**Medway Planning & Economic Development Board
Meeting**

Phytopia Public Hearing Continuation
Major Site Plan, Reduced Parking
Special Permit and Groundwater
Protection Special Permit

**Re: Phytopia Inc.
 Major Site Plan Review
 6 Industrial Park Road
 Medway, Massachusetts**

DRAWING: C9.1

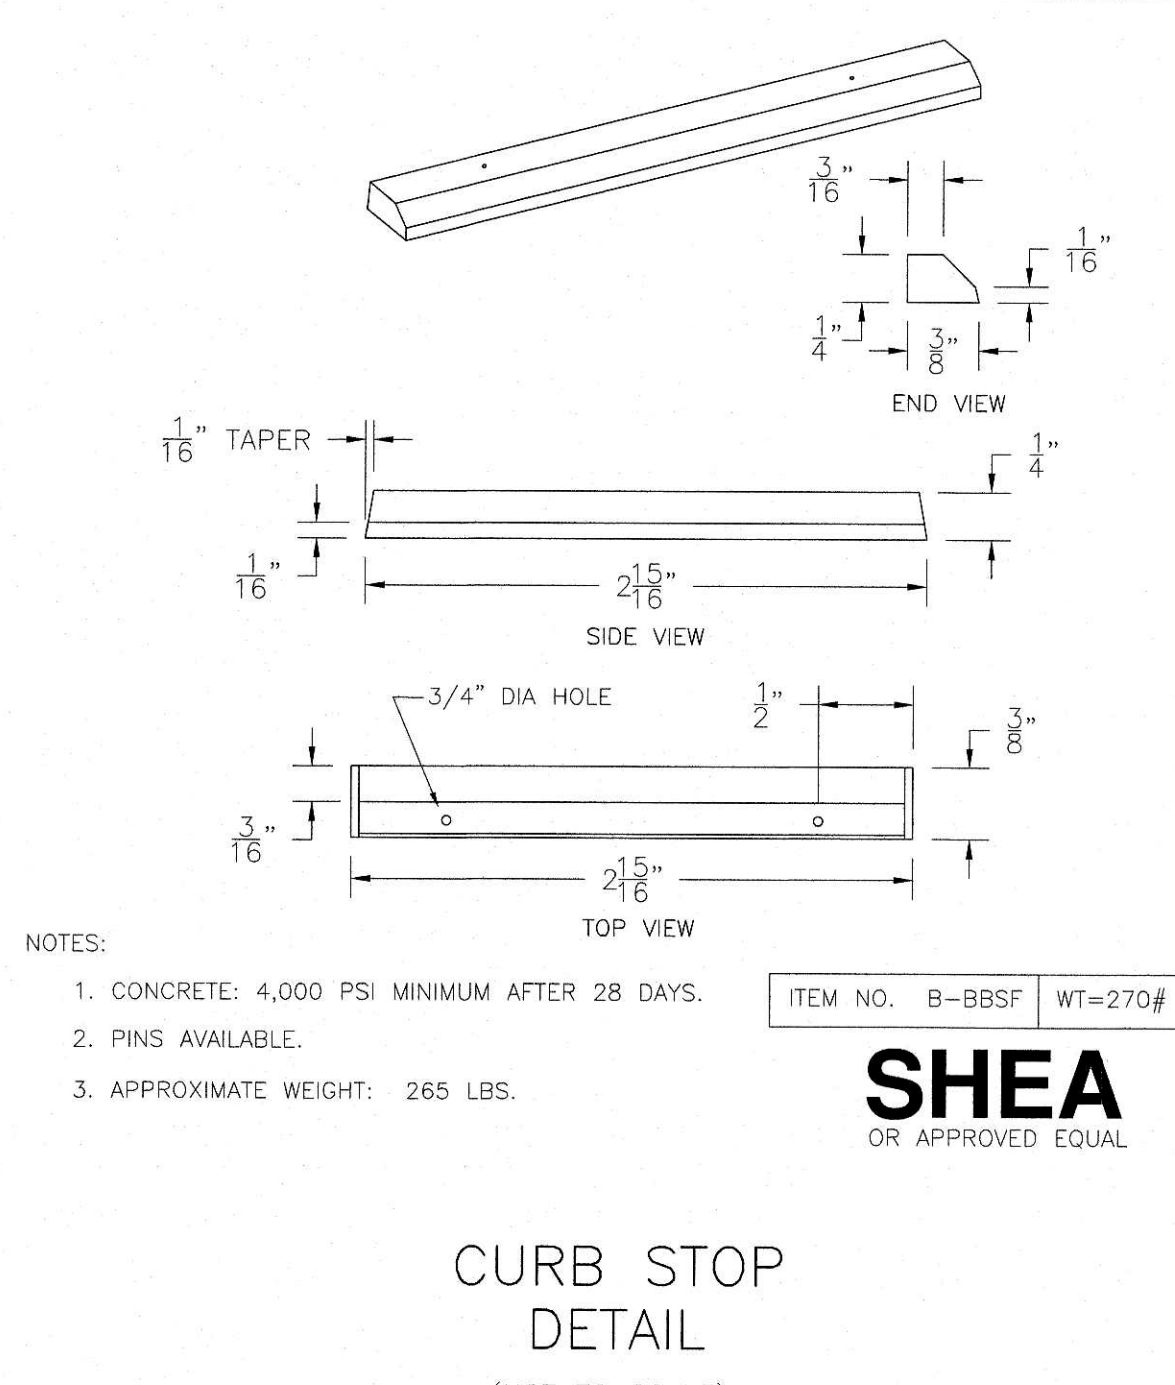
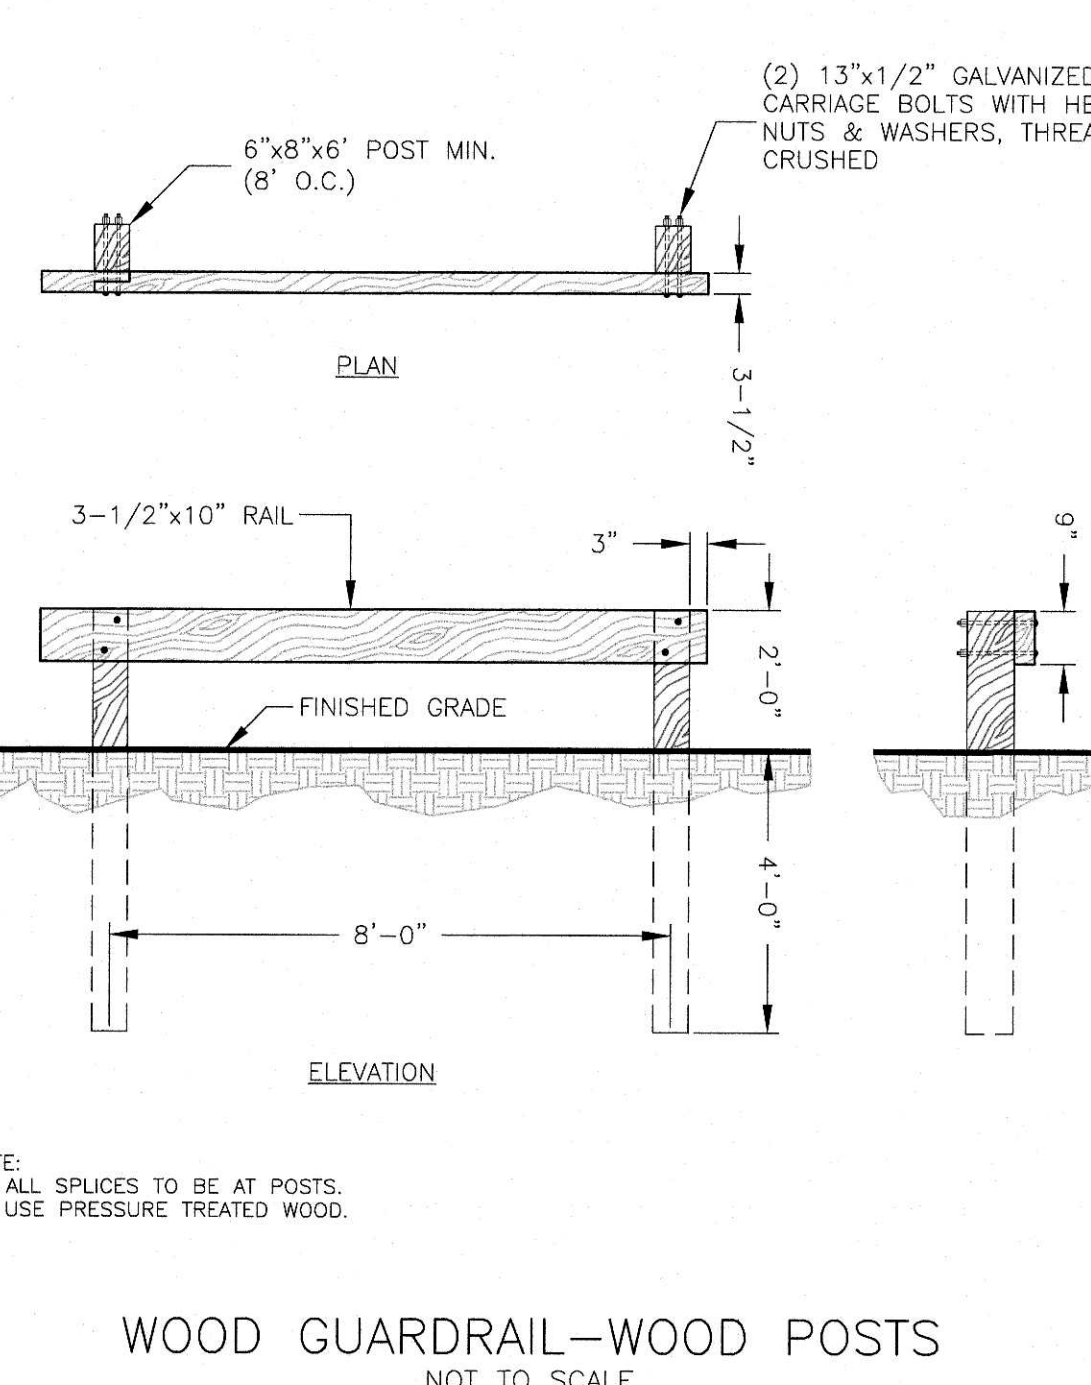
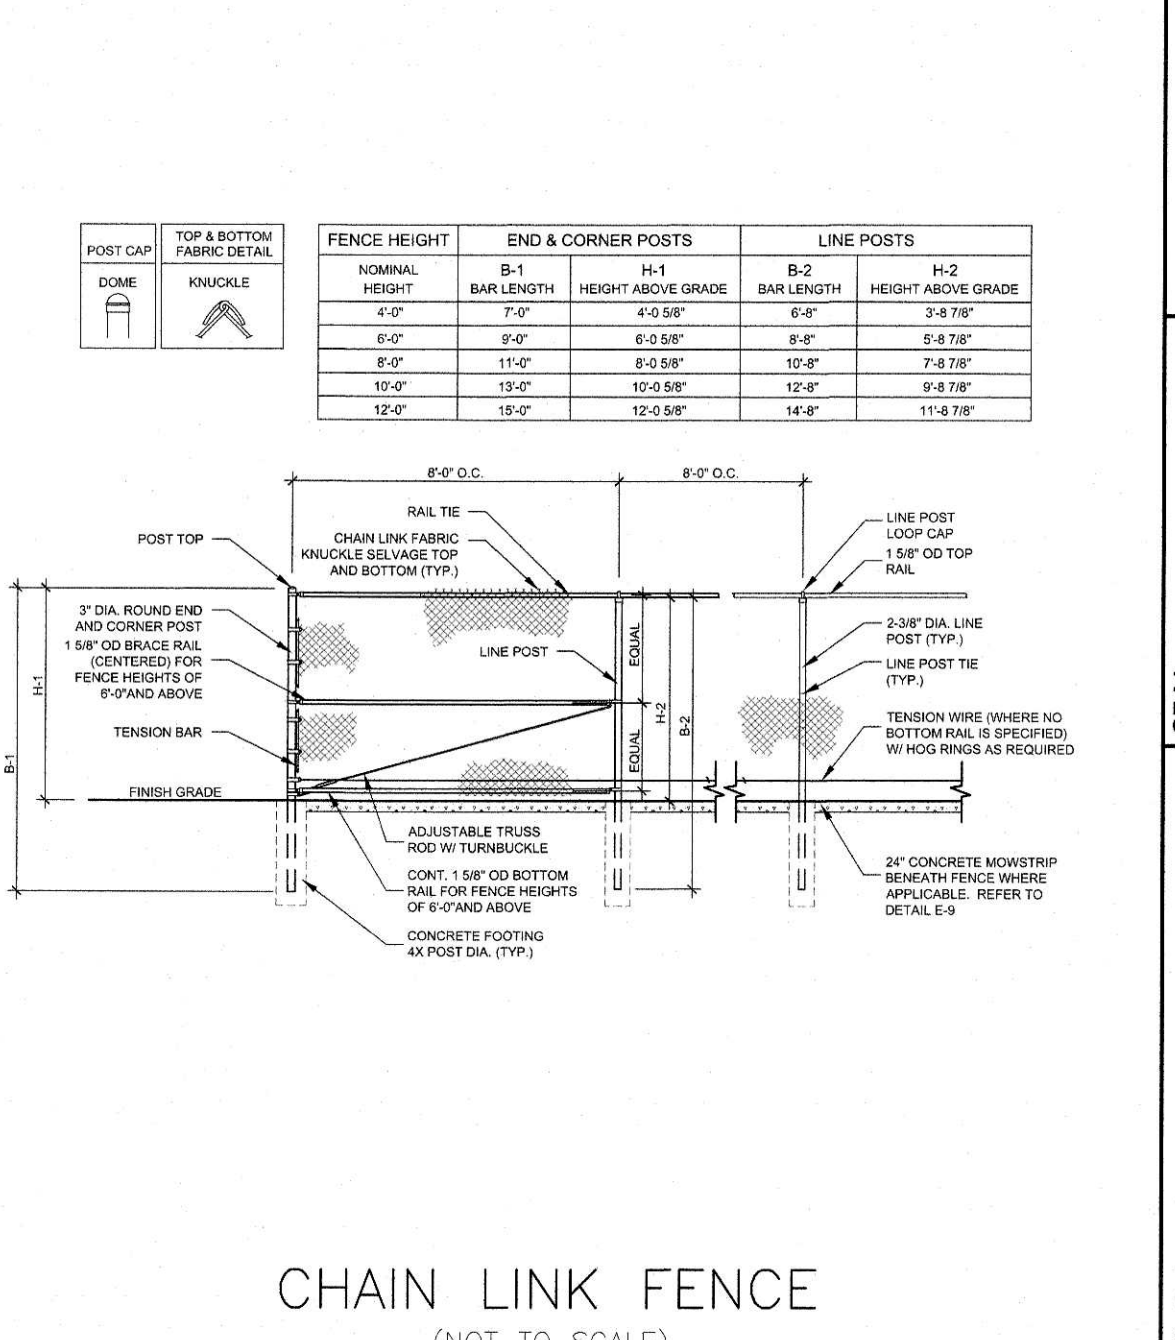
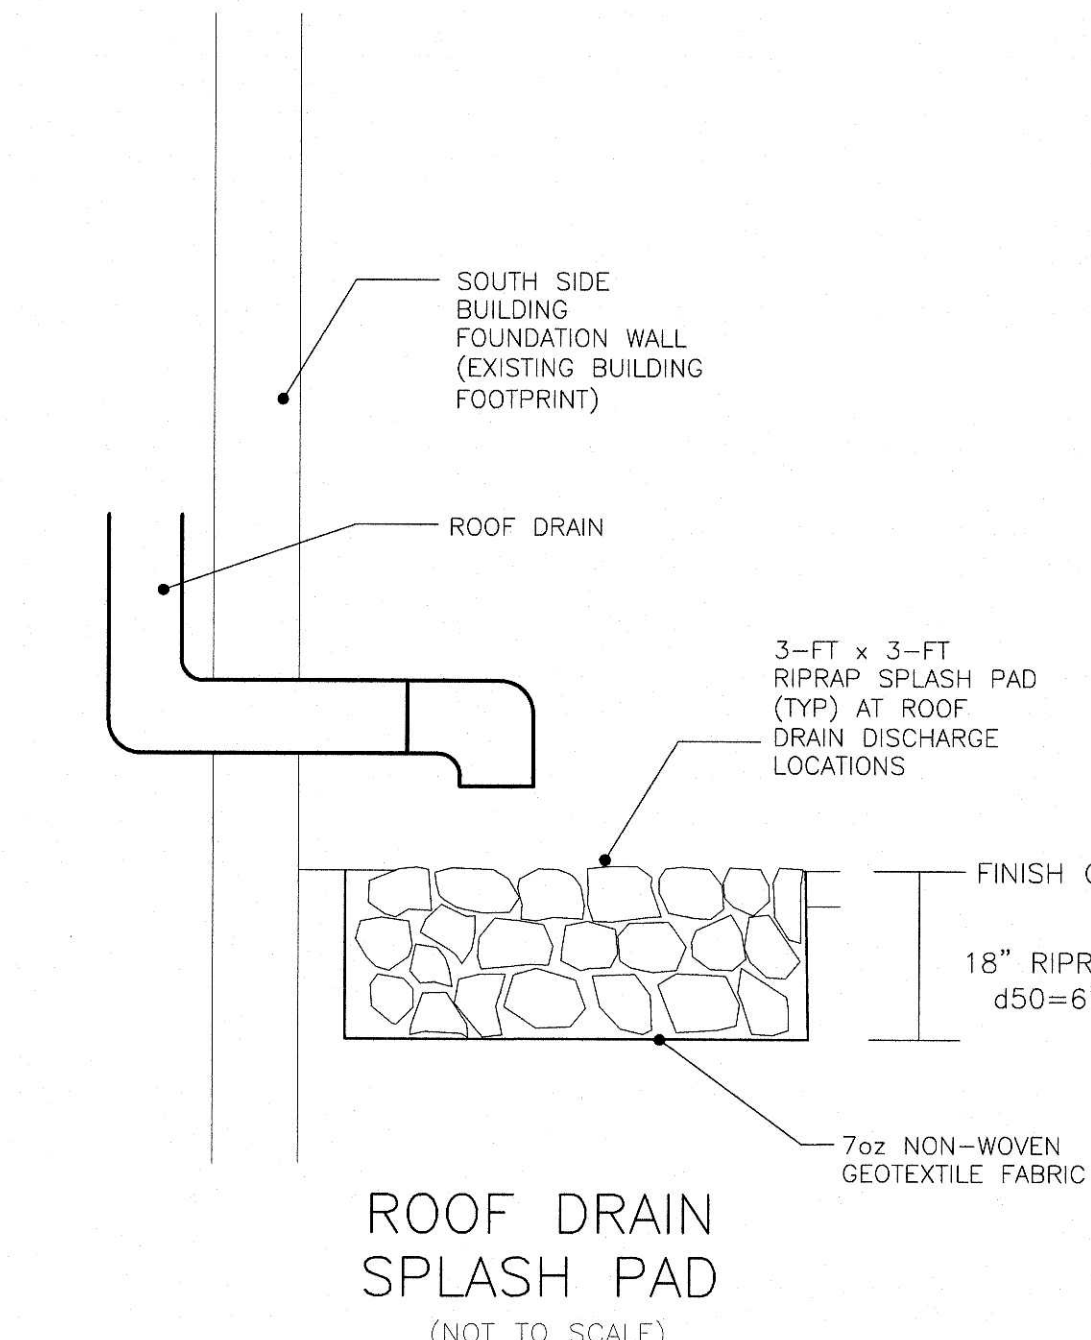
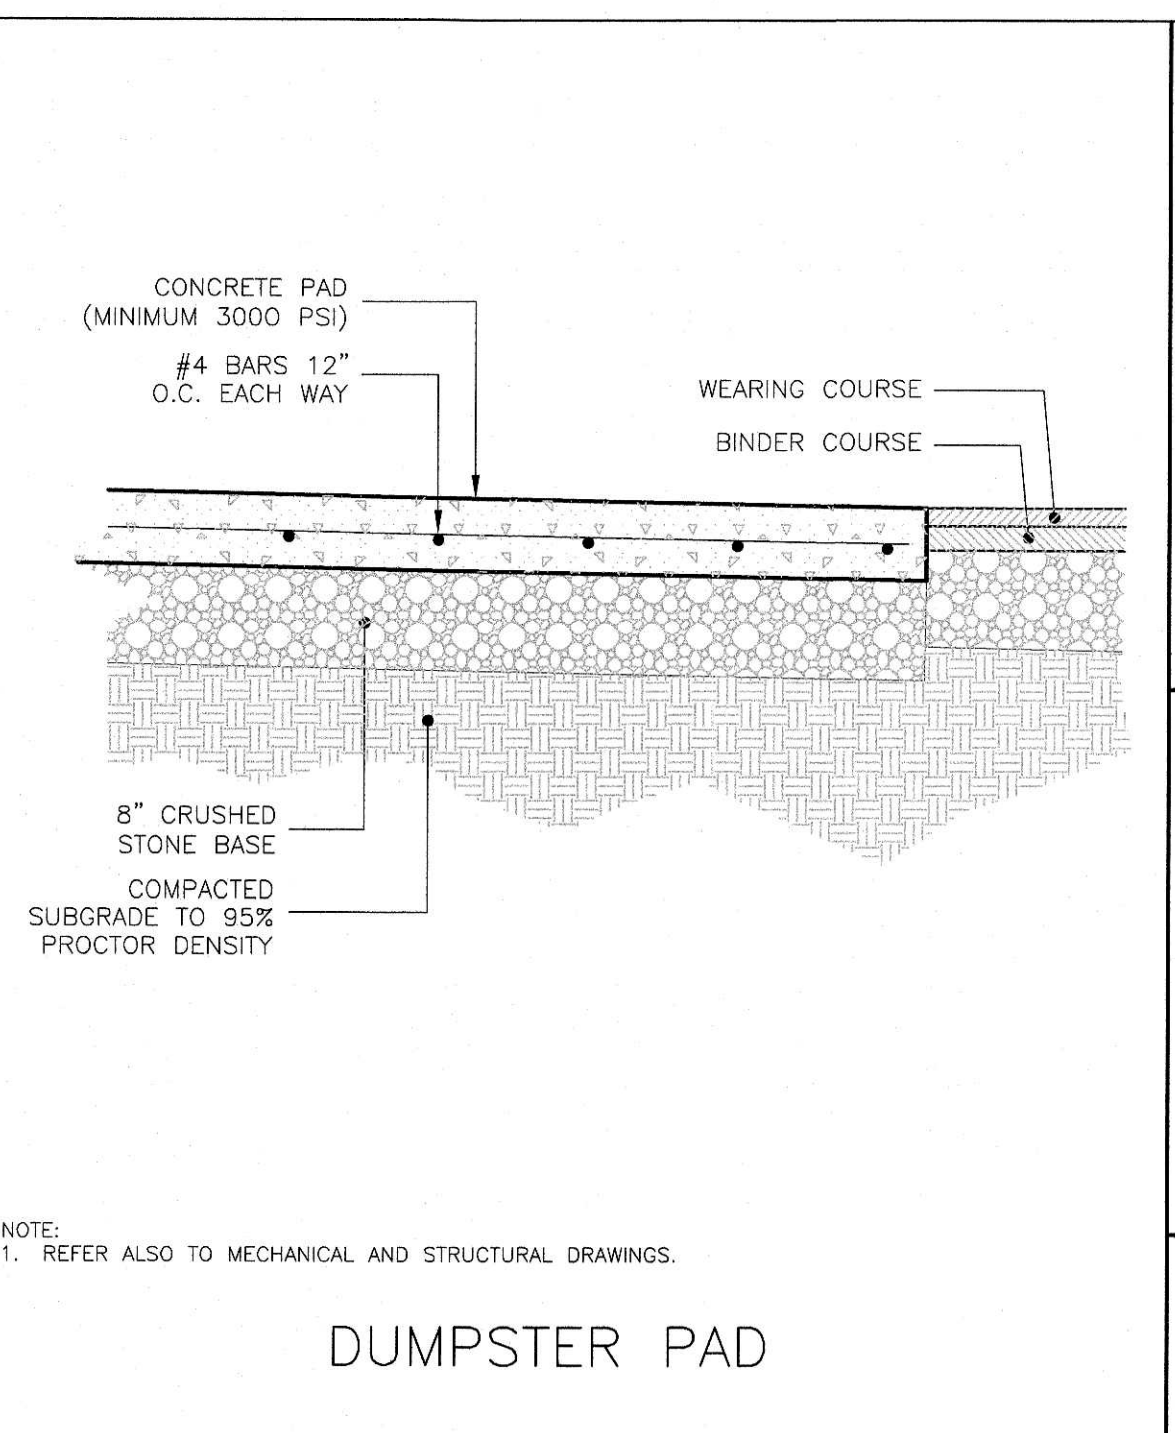
37. Mulch sock should be depicted in the "Siltfence with Mulch Sock" detail on the Construction Details Plan.
- *WSE 10/12/21 Response: Mulch sock is depicted on the Construction Details Plan, see sheet 9.*

- **TT 10/27/21 Update: The detail does not appear to be correct as certain information is missing on the detail or is not showing up correctly when printed from CAD.**

- *WSE 4/12/22 Response: The detail has been corrected. See sheet 10 of the plan set.*
 - **TT 4/22/22 Update: In our opinion, this comment is resolved.**
